NUCLEAR ENERGY INSTITUTE

Enclosed is modified Improved Technical Specification NUREGs NEI Technical Specification Task Force (TSTF) Traveler number TSTF-135 Rev. 3.

TSTF-135, Rev. 3

3.3 - RPS and ESFAS Instrumentation

RTS Instrumentation 3.3.1TSTF-135, Rev. 3

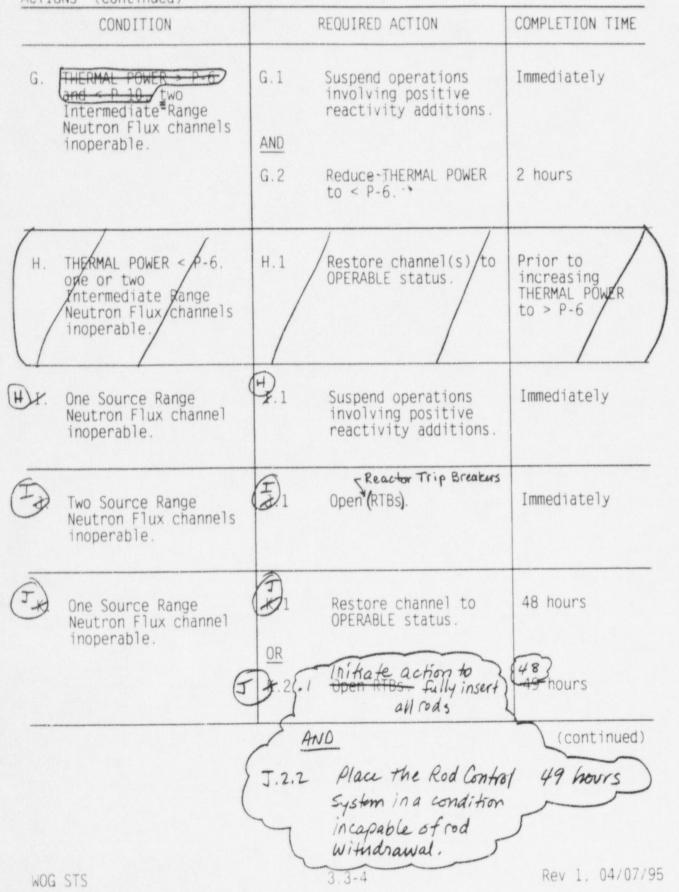
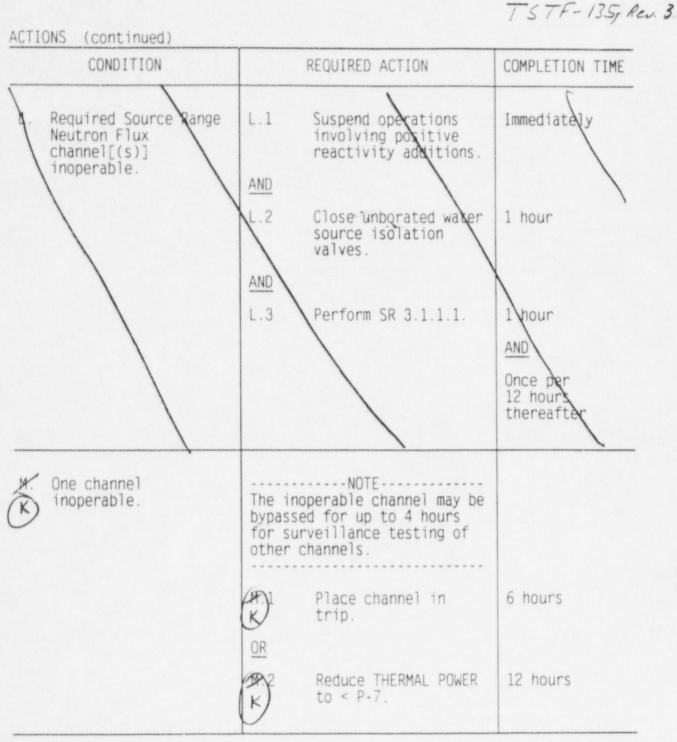
CONDITION	REQUIRED ACTION	COMPLETION TIME	
D. (continued)	Only required to be performed when the Power Range Neutron Flux input to QPTR is inoperable.		
	D.2.2 Perform SR 3.2.4.2. OR	Once per 12 hours	
	D.3 Be in MODE 3.	12 hours	
E. One channel inoperable.	NOTE- The inoperable channel may be bypassed for up to 4 hours for surveillance testing of other channels.		
	E.1 Place channel in trip.	6 hours	
	OR E.2 Be in MODE 3.	12 hours	
F. THERMAL POWER > P 6 and < P 10 one Intermediate Range	F.1 Reduce THERMAL POWER to < P-6.	2 hours	
Neutron Flux channel inoperable.	OR F.2 Increase THERMAL POWER to > P-10.	2 hours
